Well Name	Well Number	US Well Number	Lease Number	Case Number	Operator
INDIAN HILLS	17	3001530661	NMNM06293	NMNM70964A	OXY USA WTP
N INDIAN BASIN	26	3001528752	NMNM04827B	NMNM70998A	OXY USA WTP
INDIAN HILLS	52	3001532805	NMLC064243A	NMNM70964A	OXY USA WTP

Procedure Description: OXY PROPOSES TO PREP THESE WELLS FOR THE PA RIG. SEE ATTACHED PREP RIG STEPS AND WELL CONTROL PRECAUTIONS.

Procedure Description: OXY USA WTP LP respectfully request approval to plug and abandon the subject well. The proposed plugging plan, current wellbore diagram and proposed wellbore diagram are attached.

INDIAN HILLS #52

Proposed Wellbore

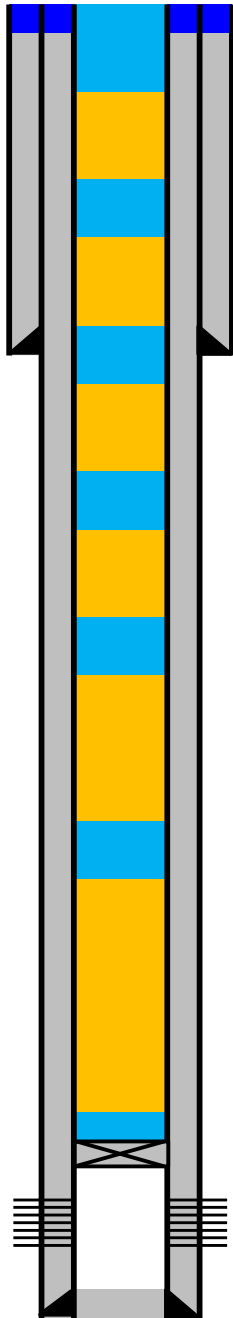
1. SET CIBP AT 8026'. SPOT ~~10~~ SX CLASS H CMT 8026'-~~7991~~'. WOC AND TAG. 25 Sacks 8026'-7873'
2. RUN CBL 7980'-SURFACE.
3. SPOT 25 SX CLASS H CMT ~~7253~~'-~~7117~~'. WOC AND TAG. 7180' to 6926' 52 Sacks
4. SPOT 25 SX CLASS C CMT ~~5196~~'-~~5060~~'. WOC AND TAG. 3926' to 3787' (Bone Springs at 3876')
5. SPOT ~~25~~ SX CLASS C CMT ~~2912~~'-~~2776~~'. WOC AND TAG. 3056' to 2777'. 46 Sacks
6. SPOT 25 SX CLASS C CMT 1882'-1746'. WOC AND TAG.
7. SPOT 25 SX CLASS C CMT 1252'-1116'. WOC AND TAG.
8. SPOT 95 SX CLASS C CMT 500'-SURF. WOC AND VERIFY CMT AT SURF.

Plug Type	Top	Bottom	Length	Tag	Sacks	Cement Class	Notes
Surface Plug	0.00	100.00	100.00	Tag/Verify			
				If solid base no need to Tag (CIBP present and/or Mechanical Integrity Test), If Perf & Sqz then Tag, Leak Test all CIBP if no Open Perforations			
Fresh Water @ 350	296.50	400.00	103.50	ns	82.00	C	Spot cement from 500' to surface.
				If solid base no need to Tag (CIBP present and/or Mechanical Integrity Test), If Perf & Sqz then Tag, Leak Test all CIBP if no Open Perforations			
San Andres @ 1200	1138.00	1250.00	112.00	ns	25.00	C	Spot cement from 1250' to 1138'. WOC and Tag.

9.625 inch- Shoe Plug	1763.68	1882.00	118.32	Tag/Verify	25.00	C	Spot cement from 1882' to 1763'. WOC and Tag.
Glorieta @ 2856	2777.44	2906.00	128.56	If solid			
				If solid base no need to Tag (CIBP present and/or Mechanical Integrity Test), If Perf & Sqz then Tag, Leak Test all CIBP if no Open Perforations			
Yeso @ 3006	2925.94	3056.00	130.06	ns	46.00	C	Spot cement from 3056' to 2777'. WOC and Tag.

If solid base no need to Tag (CIBP present and/or Mechanical Integrity Test), If Perf & Sqz then Tag, Leak Test all CIBP if no Open Perforations			
Bonesprings @ 3876	3787.24	3926.00	138.76	ns	25.00	C	Spot cement from 3926' to 3787'. WOC and Tag.
				If solid base no need to Tag (CIBP present and/or Mechanical Integrity Test), If Perf & Sqz then Tag, Leak Test all CIBP if no Open Perforations			
Wolfcamp @ 7130	6926.00	7180.00	254.00	ns	52.00	H	Spot cement from 7180' to 6926'. WOC and Tag.
				If solid base no need to Tag (CIBP present and/or Mechanical Integrity Test), If Perf & Sqz then Tag, Leak Test all CIBP if no Open Perforations			
CIBP Plug	7991.00	8026.00	35.00	ns	25.00	H	Set CIBP at 8026'. Spot 25 sxs on top. WOC and Tag.
Perforations Plug (If No CIBP)	8026.00	8498.00	472.00	Tag/Verify			
7 inch- Shoe Plug	8626.36	8814.00	187.64	Tag/Verify
